RESIDENTIAL ENGINEERING SERVICES, LLC.
SHOP DRAWINGS/SUBMITTAL REVIEW

JOB No.	2623880
DESCRIPTION	Summit - 100 Manor at Stoney Creek
JOB ADDRESS	4413 SW Tanzanite Circle
CITY	Lee's Summit, MO
DESIGNER	Scott Cleverger
DATE	2/5/2021

ROOF
TRUSS LAYOUT

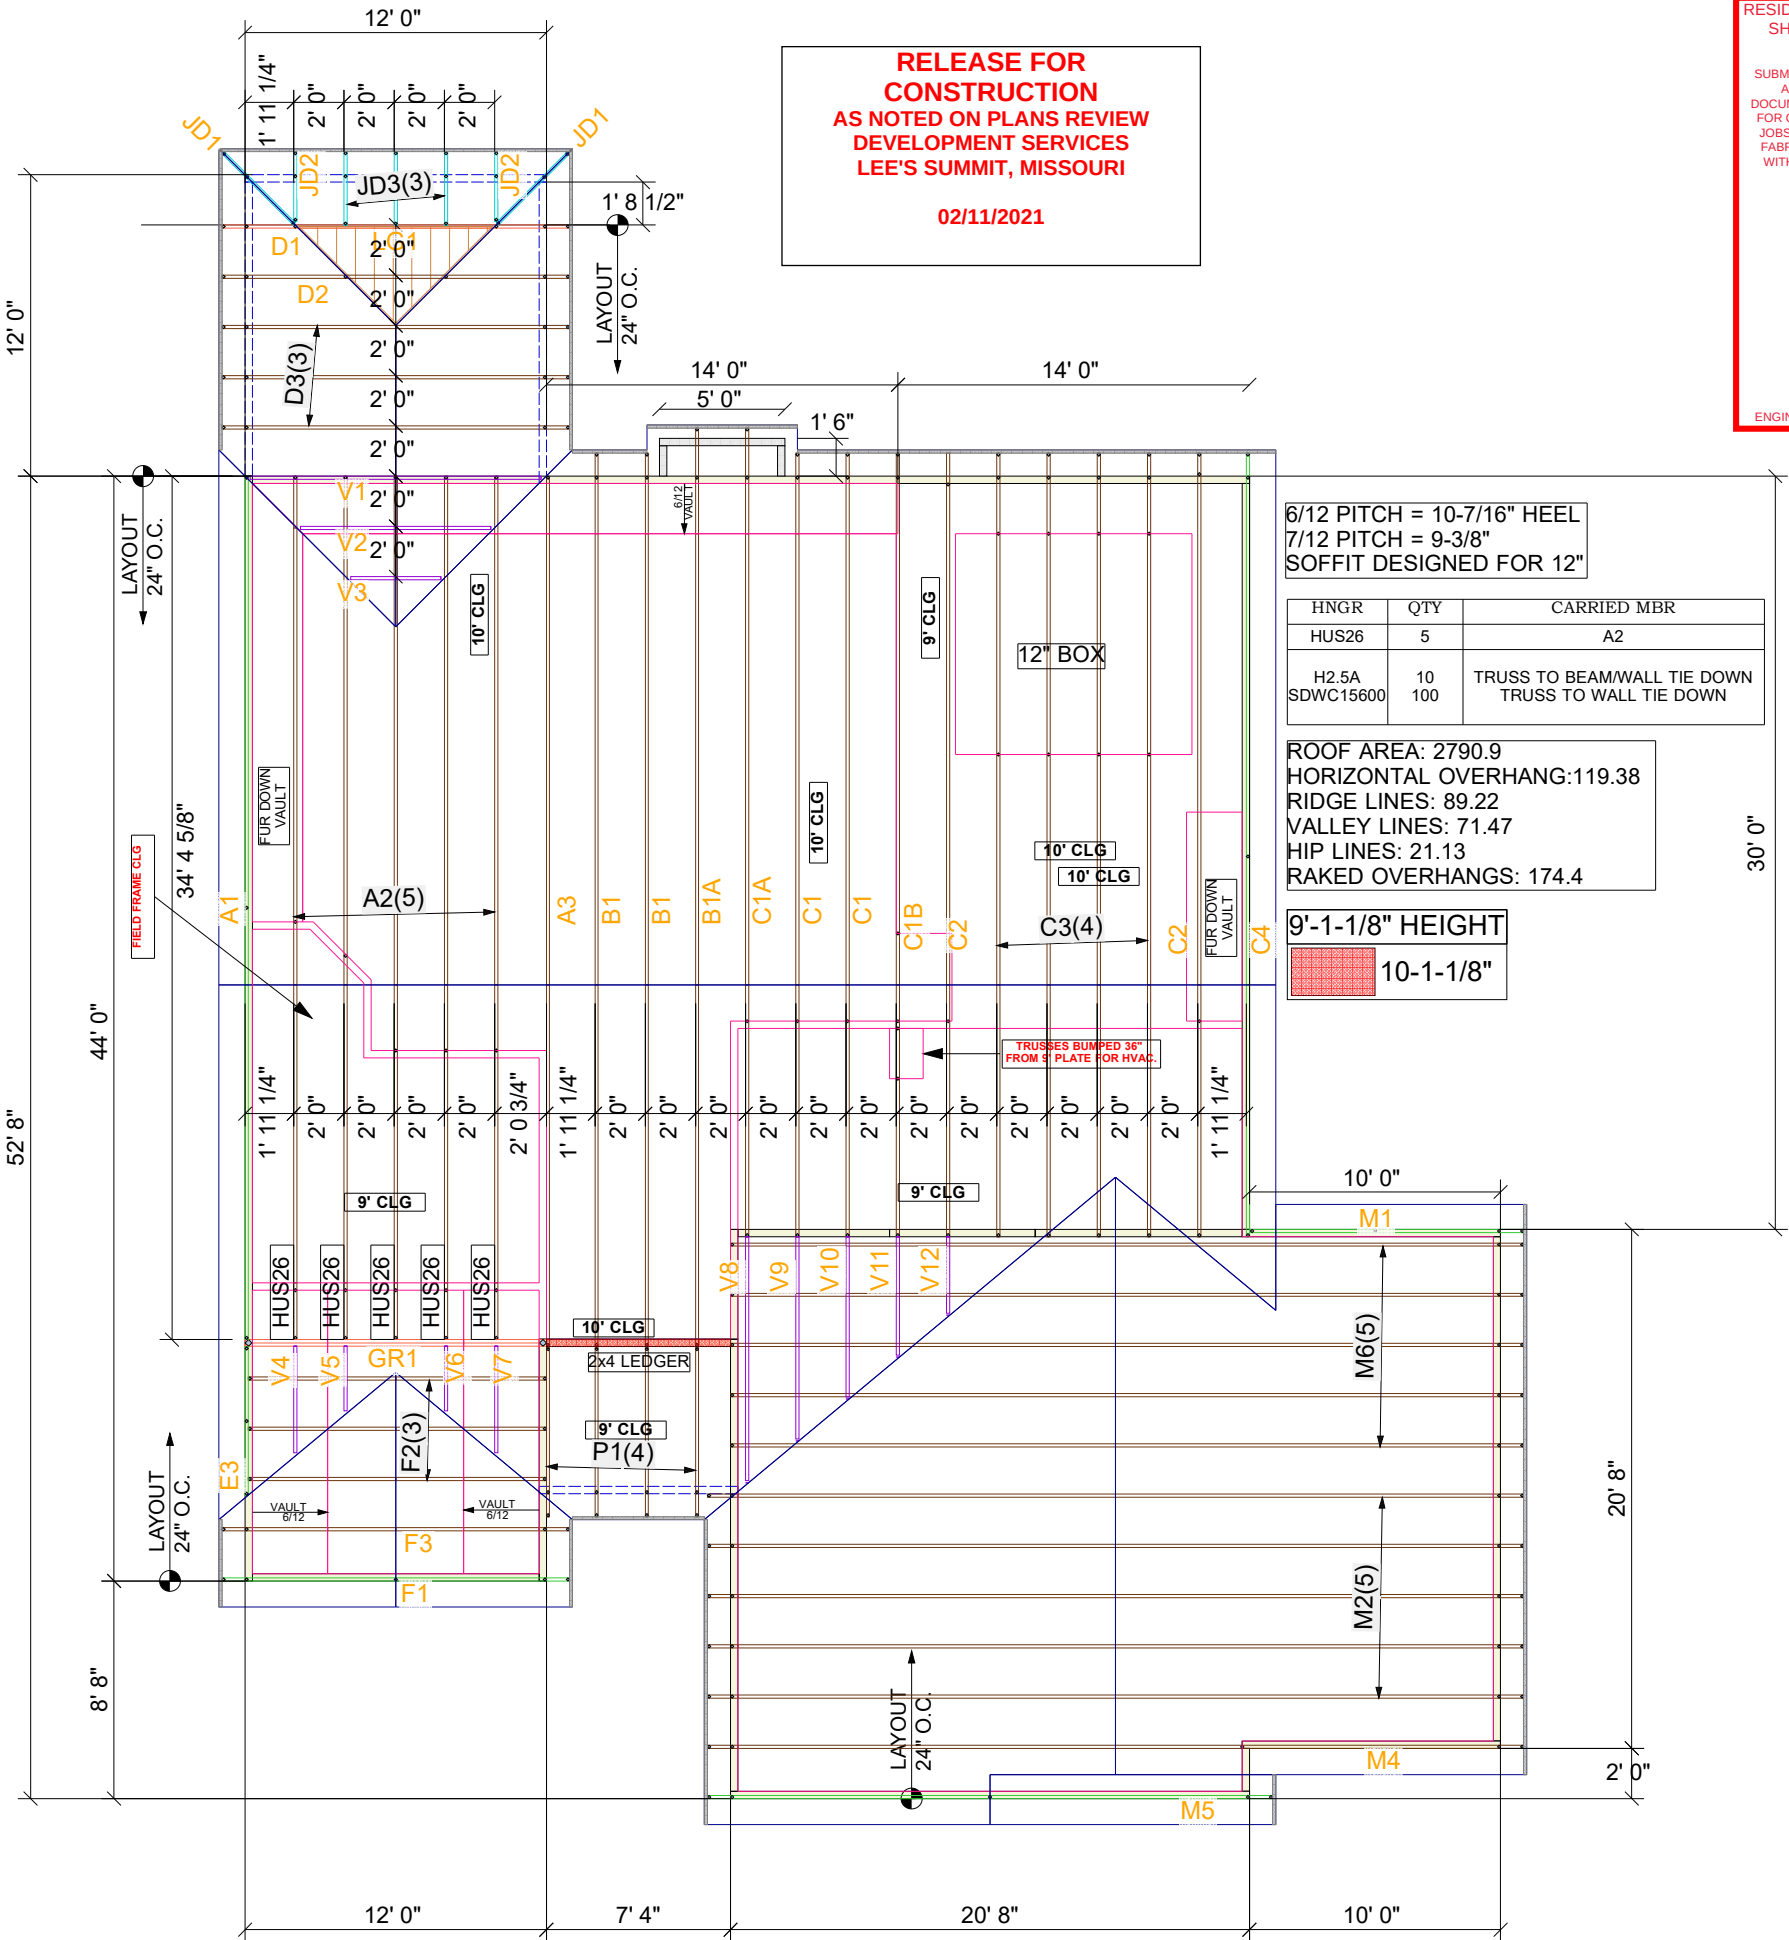
APPROVED
